**A RESOLUTION OF THE CITY COUNCIL OF
THE CITY OF MERCED, CALIFORNIA,
ADOPTING THE MERCED VISION 2030
GENERAL PLAN**

**MERCED VISION 2030 GENERAL PLAN
OPTION 3**

Proposed Changes Since August 2010 Public Review Draft

EXHIBIT 1

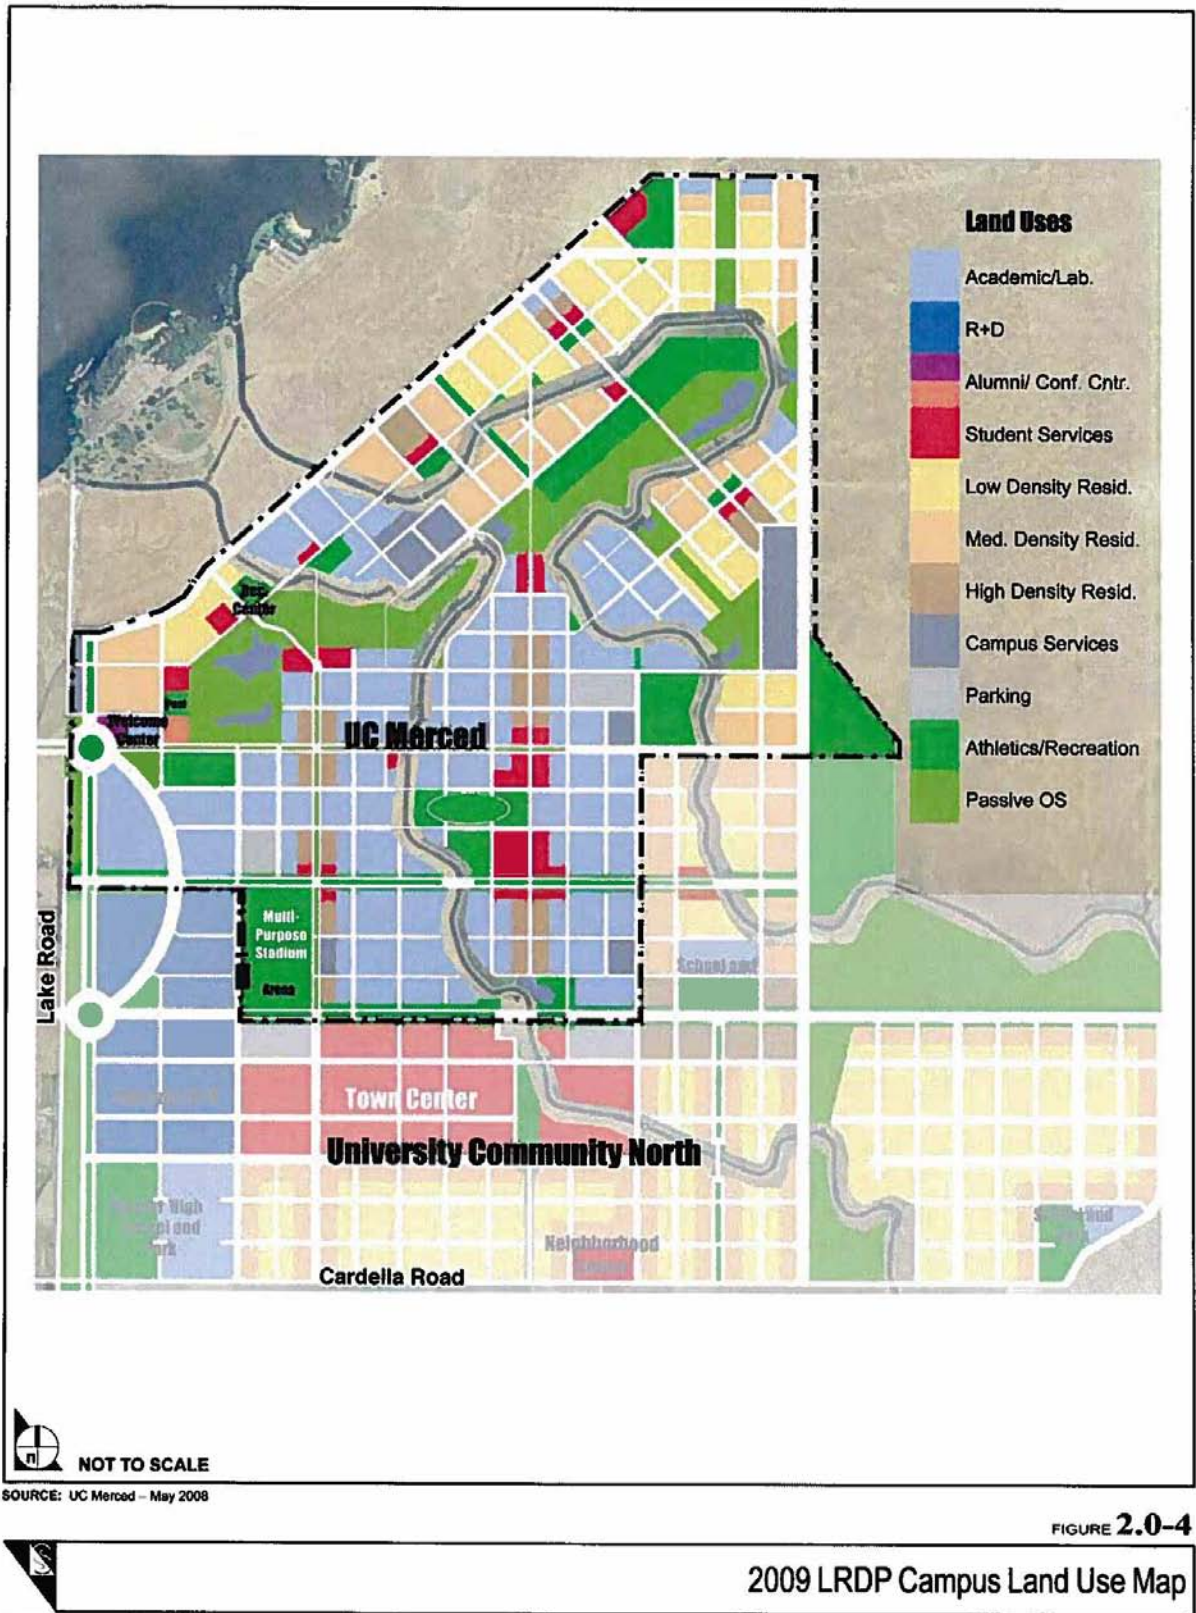
#	Pg.	¶	Col.	Change	Source
1	--	--	--	Various Figures, Maps, and Table throughout the General Plan document will be modified to reflect the 2009 UC Merced and University Community North boundaries as adopted by the UC Board of Regents in 2009. This will include changes to the Land Use Diagram and SUDP/SOI boundary for those areas only. See Exhibit 1 for the 2009 UC/UCP boundaries.	CS/UC

Figure 4.27f
Yosemite Avenue (East of Parsons/Gardner) Special Section

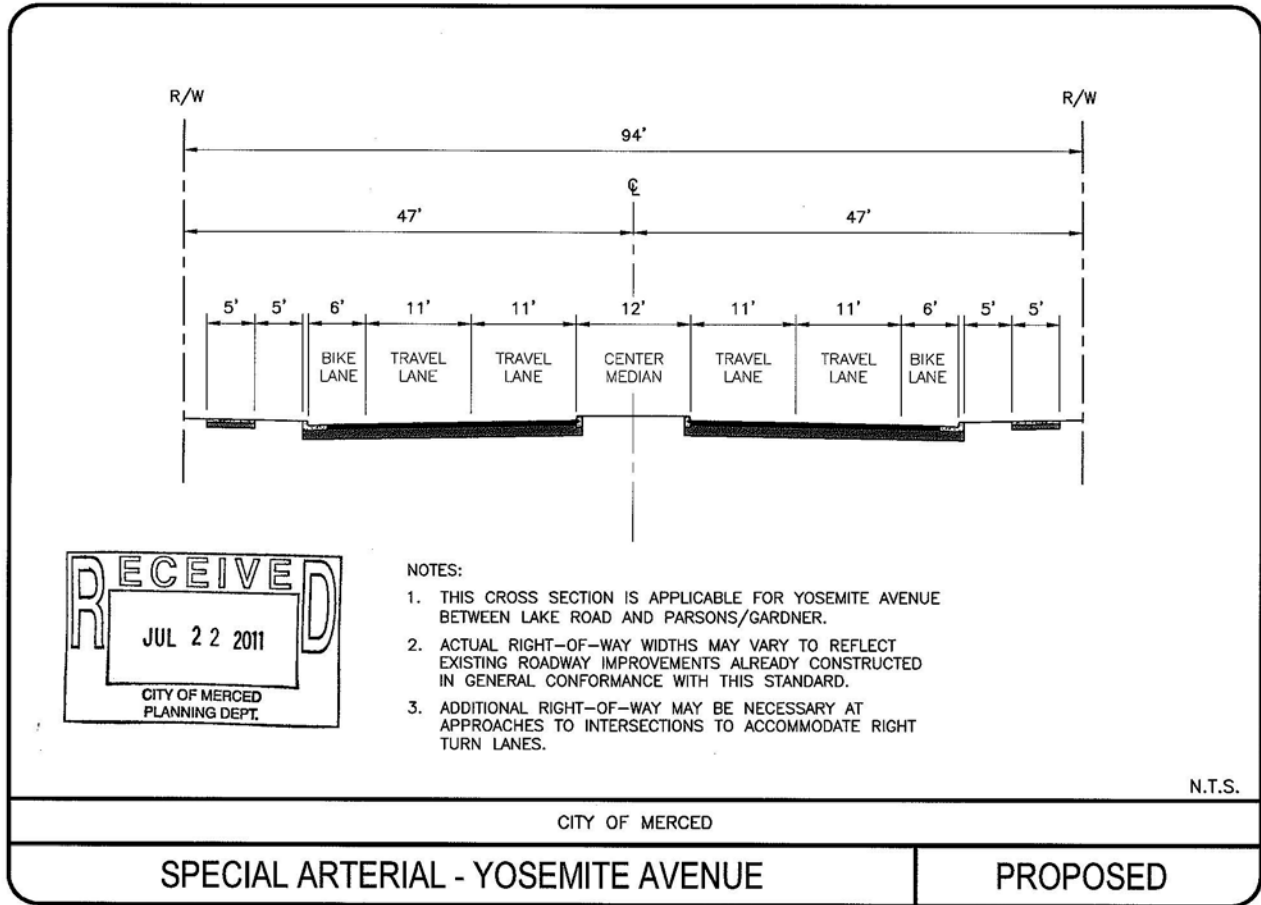
EXHIBIT 4

Land Use Diagram

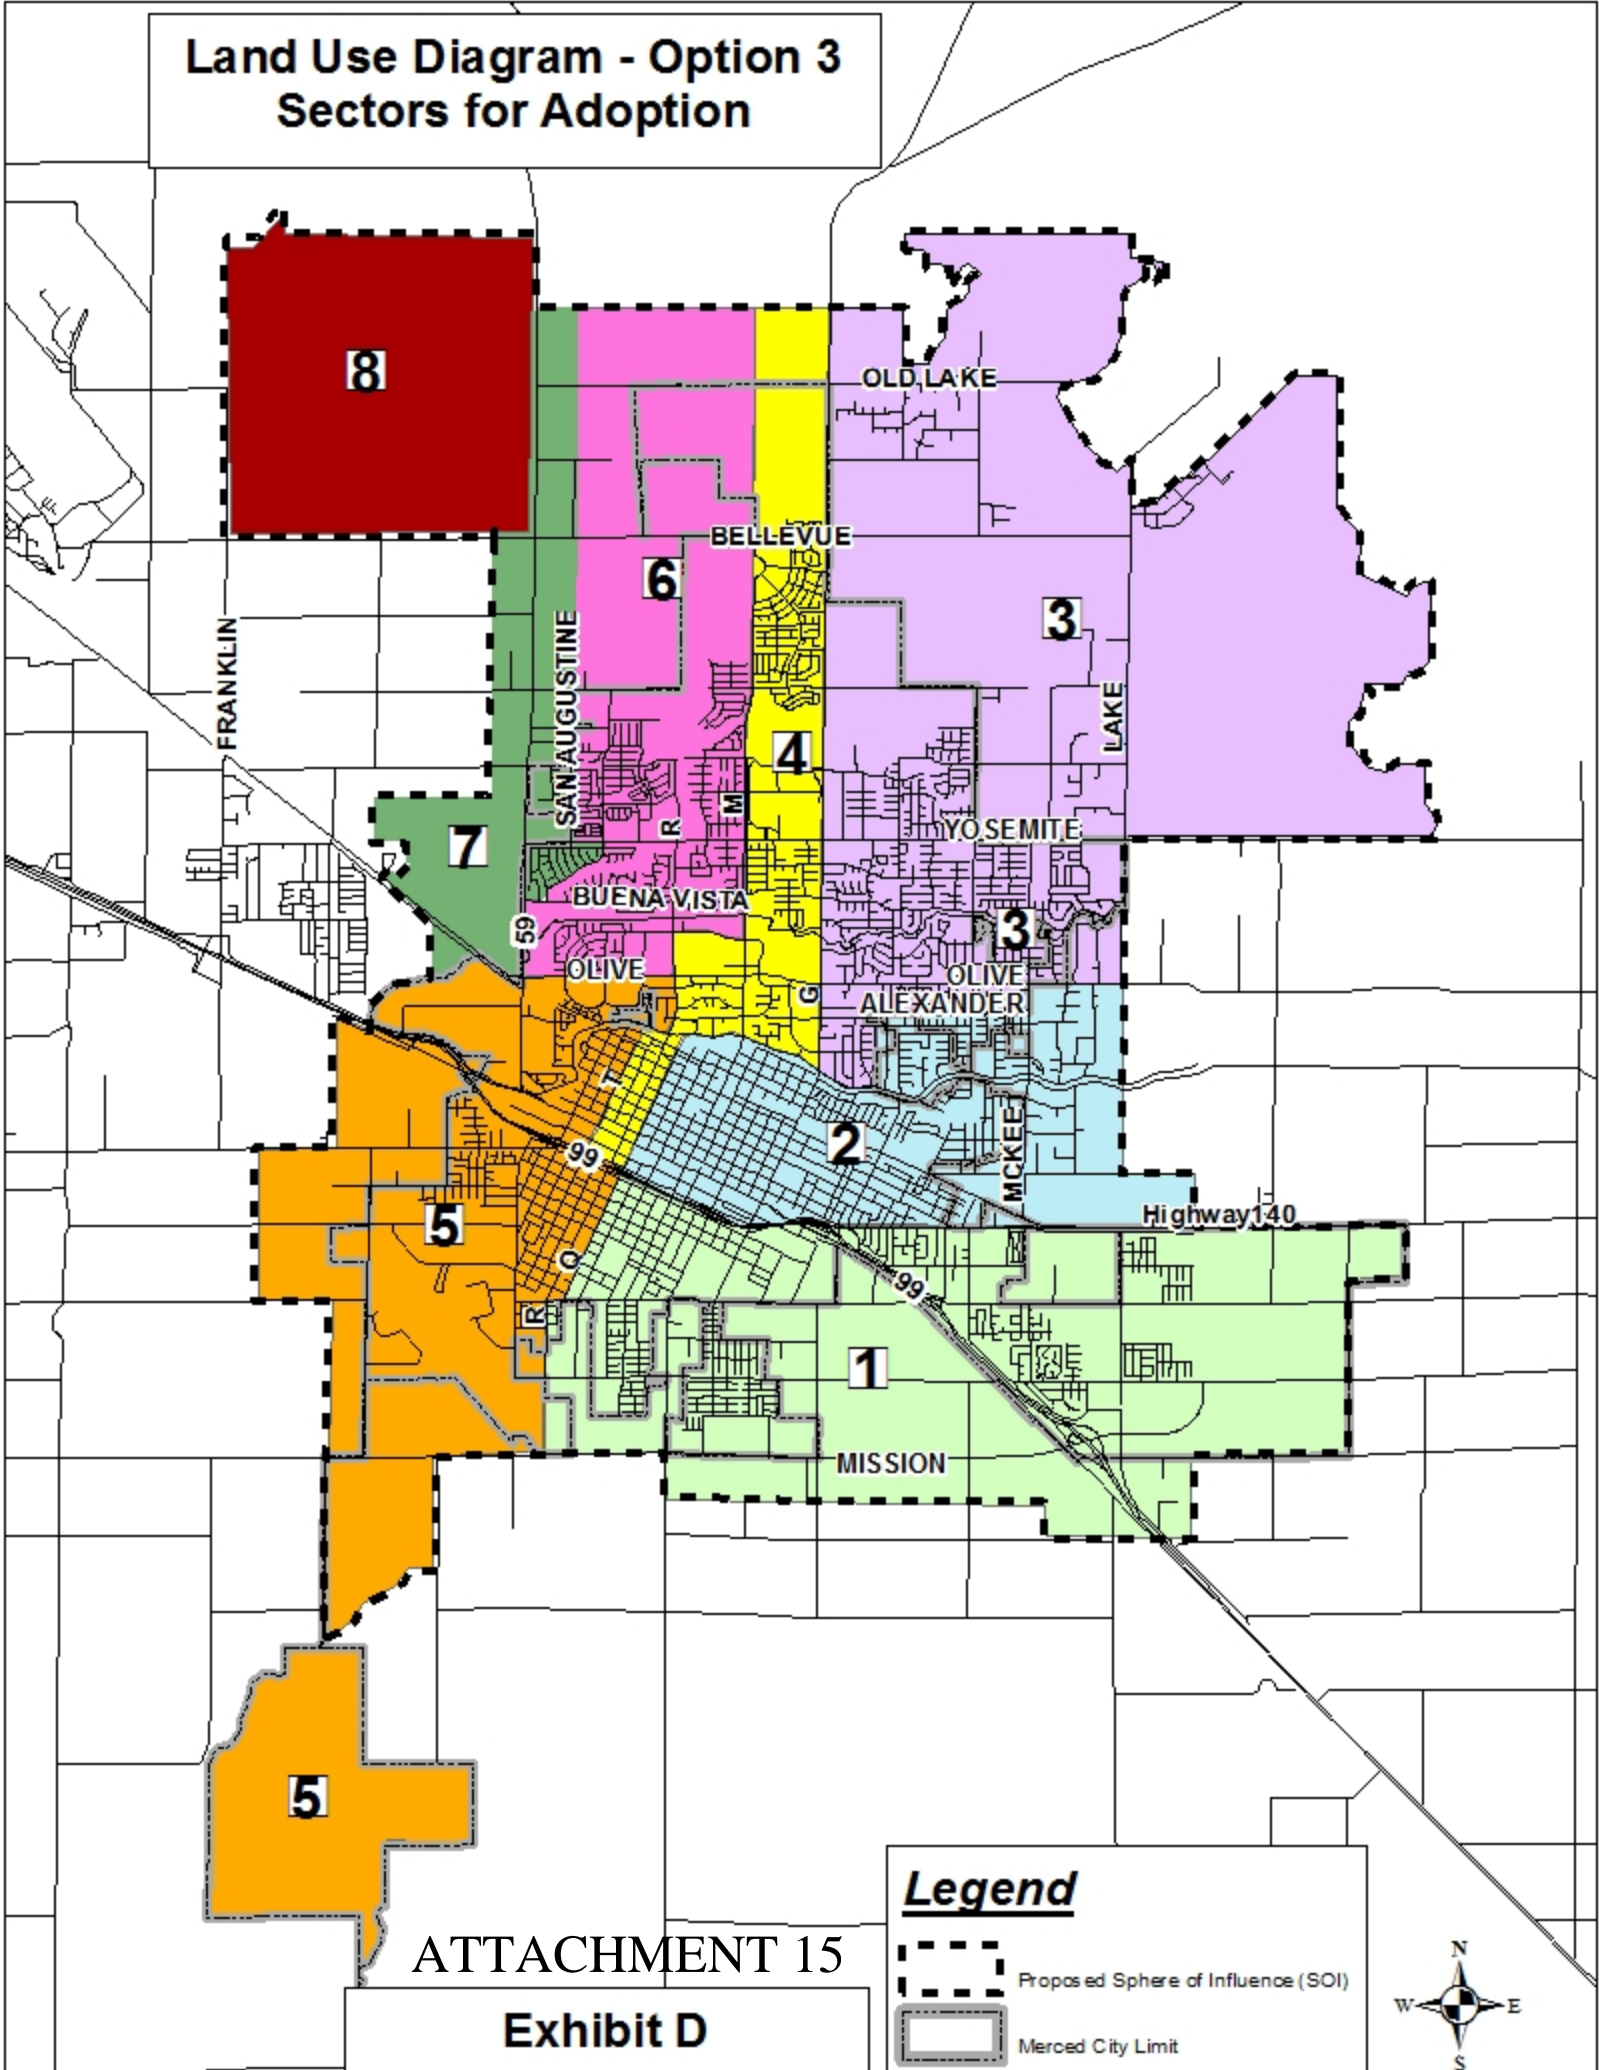
#	APN#	Location	Designation on Land Use Diagram (8/24/10)	Corrected Designation	Source
1	52-300-021 52-300-024 52-300-26 60-010-001 60-020-007 (UC 815 acres & Univ Comm North 833 acres)	Northeast and Southeast corners of Bellevue Rd & Lake Rd (UC Merced Campus & University Community)	School and Community Plan	Designations of School (SCH) and Community Plan (CP) remain but the boundaries change per Exhibit 1	The UC Board of Regents adopted an EIR for the revised boundaries for the UC Merced Campus & University Community North on March 25, 2009.
2	057-200-076 (40 acres)	West of Highway 59, north of Santa Fe Drive	Business Park (BP)	Regional/Community Commercial (RC)	Property owner request to retain 1997 General Plan land use designation
3	052-230-083 (58 acres)	Southwest corner of G and Farmland	Low Density Residential (LD)	School (SCH)	GPA #07-02 11-15-2010 CC Res# 2010-89
4	224-212-001, -002, -003, -8, -009, -010, -012, -013 (1.7 acres)	Northeast corner of Bancroft and Cardella	Fire Station (PG)	Low Density Residential (LD)	GPA #08-03 8-2-2010 CC Res #2010-71

5	058-020-058 (2.5 acres)	Southeast corner of Hwy 59 & Buena Vista	Business Park (BP)	Neighborhood Commercial (CN)	GPA #09-01 5-18-2009 CC Res #2009-37
6	058-290-036 (1 acre)	South of Yosemite, east of R Street	Low Density Residential (LD)	Business Park (BP)	GPA #09-02 8-17-2009 CC Res #2009-60
7	231-010-009 (42 acres)	Southwest corner of Gardner and Cardella	Low Density Residential (LD)/Low Medium Density Residential (LMD)	Commercial/Professional Office (CO) & Low Medium Density Residential (LMD)	GPA #09-03 11-16-2009 CC Res #2009-81

#	APN#	Location	Designation on Land Use Diagram (8/24/10)	Corrected Designation	Source
8	030-204-007, & -008 (15,000 SF)	Southwest corner of W 24 th and G Streets	High Medium Density Residential (HMD)	General Commercial (CG)	GPA #10-01 3-15-2010 CC Res #2010-21
9	231-040-004, -005, -006 (11.5 acres)	Northeast corner of Yosemite & G	High Medium Density Residential (HMD)	Commercial/ Professional Office (CO)	GPA #10-02 8-2-2010 CC Res #2010-73
10	006-061-005 (14,000 SF)	North of Donna/East of G Street (PD #26)	Low Density Residential (LD)	Commercial/ Professional Office (CO)	GPA #10-04 11-15-2010 CC Res #2010-100
11	Not Applicable	Kibby Road (between Childs & Gerard Ave)	Collector Street shown from Childs to Gerard	Kibby Road has been vacated from Childs to Gerard	GPA #06-01/ Vacation #06-01 9-28-2009 CC Res #2009-69/ CC Res #2009-70
12	007-350-005, -006, & -007 (8.8 acres)	Southwest corner of West Olive Ave & G Street	Neighborhood Commercial (CN)	Regional/ Community Commercial (RC)	GPA #11-01 9-6-2011 CC Res #2011-59

13	065-080-020, -021, -022, -029, -035, -036, -048, -049, -052 thru -058, -060, -062, & -063; 065-090-003, -004, -006, 008, -009, 012 thru -024 (Approx. 2,500 acres)	Southwest corner of South Highway 59 & Mission Ave (Mission Lakes)	Community Plan (CP), within SUDP/SOI boundary	Area of Interest (AOI), outside of SUDP/SOI boundary	City Council Direction on 9-19-2011
